## **EUROMOT POSITION**

**20 Nov 2014**

### **Euromot Response to CEFIC Comments as of 17 July 2014**

## **B. Response to the CEFIC comments by Mr. P. Cassaghi dated 17 July 2014**

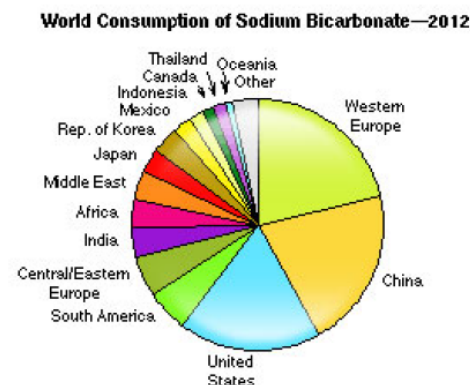
“Novel Dry FGD used in Maltese case study, see ANNEX 1  
– No long-term experience exists.”

**Dry Bicarbonate FGD has been implemented for 25 years in. Hundreds of references exist worldwide nowadays. Many of them operate in similar conditions of pollutants and temperature. The technic has already been referenced in current BREF LCP issued in 2006 based on data collected in 2003.**

We agree that dry bicarbonate FGD is a well-known and well used technology in context with (smaller) boiler and waste incinerator plants /9/. Many references delivered by several companies can be found on these kind of applications. However, CEFIC did not take into account that our presentation material sent to the LCP BREF update June 2014 Interim TWG meeting **was targeting stationary diesel engine plants**. Diesel engine and boiler flue gases are substantially different which e.g. LCP BREF 2006 /1/ document in chapter 6.1.10.3.1 also notes:

Hence, operational experience from boiler plants **cannot be directly applied** on diesel engine based plants without proper testing. A dry FGD process shall besides SO<sub>2</sub> also reduce particulate emissions.

In chapter 3.3.5.2 of the LCP BREF 2006 /1/ the dry bicarbonate FGD process is described as an emerging technology for (old) **small boiler** plants.

Euromot is not aware at all of any bigger HFO fired stationary diesel engine plant with long term experience with the dry bicarbonate FGD and thus we maintain our position that it is too early yet to base SO<sub>2</sub> and particulate emission BAT limits on this technology.

**We maintain our Position that the dry bicarbonate FGD is not BAT for a (bigger) liquid fired stationary engine plant.**

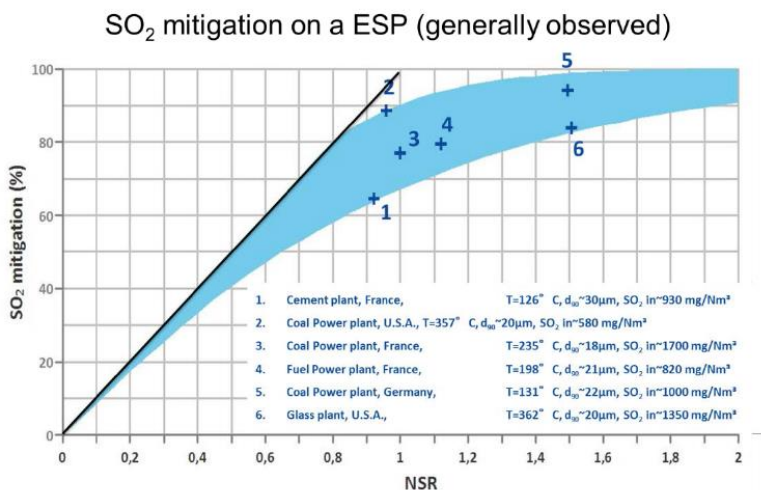
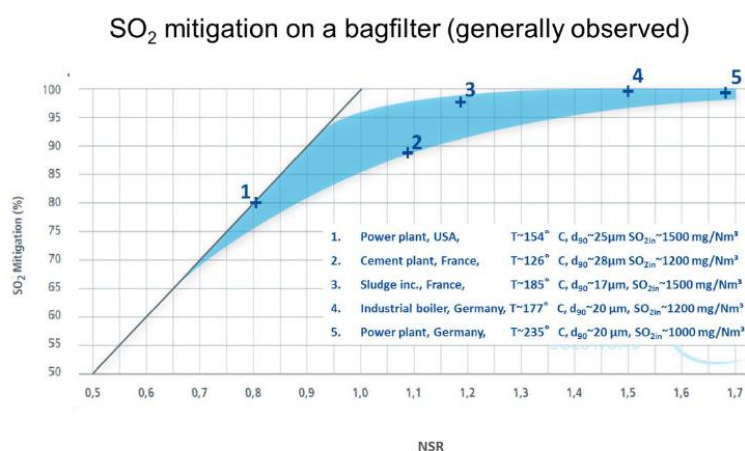
“Dry FGD is not suitable for high sulfur HFO:

- A low sulphur HFO fuel is used  $S < 0.7 \text{ wt-}\%$ ,  $\text{ash} < 0.03 \text{ wt-}\%$
- If HFO is of high sulphur type high over stoichiometry is needed, increasing operating costs significantly.”

This sentence should be supported by evidences. Experiences in other industries in similar conditions and of other power plants HFO fired demonstrate there is no need for tremendously high over stoichiometry. With a stoichiometry ratio of 1,2, it's possible to achieve a mitigation rate above 90% on ESP and above 98% on bag filter. Sodium bicarbonate injection has the great advantage to be able to treat more pollutants without further investments. On the contrary, wet scrubbers are designed one for all and not able to treat more pollutants than design once installed.

We are aware and agree that a dry FGD NaHCO<sub>3</sub> reagent based system can reach high SO<sub>2</sub> reduction rates, but the amount of reagent need (stoichiometry) will then increase significantly and consequently the operation costs.

In the Delimara case a 0.7 wt-% S HFO (Heavy Fuel Oil) (equals about 400 mg/Nm<sup>3</sup> (15 % O<sub>2</sub>) SO<sub>2</sub>) was used and the proposed LCP BREF SO<sub>2</sub> limit is < 100 mg/Nm<sup>3</sup> (15 % O<sub>2</sub>). Then a

75 % SO<sub>2</sub> reduction should be required. With a 3.5 % wt-S HFO to reach the above same SO<sub>2</sub> limit an approx. 95 % reduction is needed. According to curves given by CEFIC (above): stoichiometry increases from about 0.75/0.85 to 1.2/1.55 (wide variation area in graph) when sulphur content of the HFO increases from 0.7 to 3.5 wt-% S in order to reach the in LCP BREF D1 proposed SO<sub>2</sub> limit → up **about 60 ... 200 %**.

High SO<sub>2</sub> reductions require reagent (NaHCO<sub>3</sub>) overstoichiometries in the range of 1.2 – 1.55 (or even higher in case of ESP in place of bag filter). The largest part of the FGD operating costs is the sorbent/reagent cost. At reagent overstoichiometries the end product will in the NaHCO<sub>3</sub> case also contain a lot of unreacted sodium carbonate and bicarbonate. A high overstoichiometry has a large impact on the OPEX.
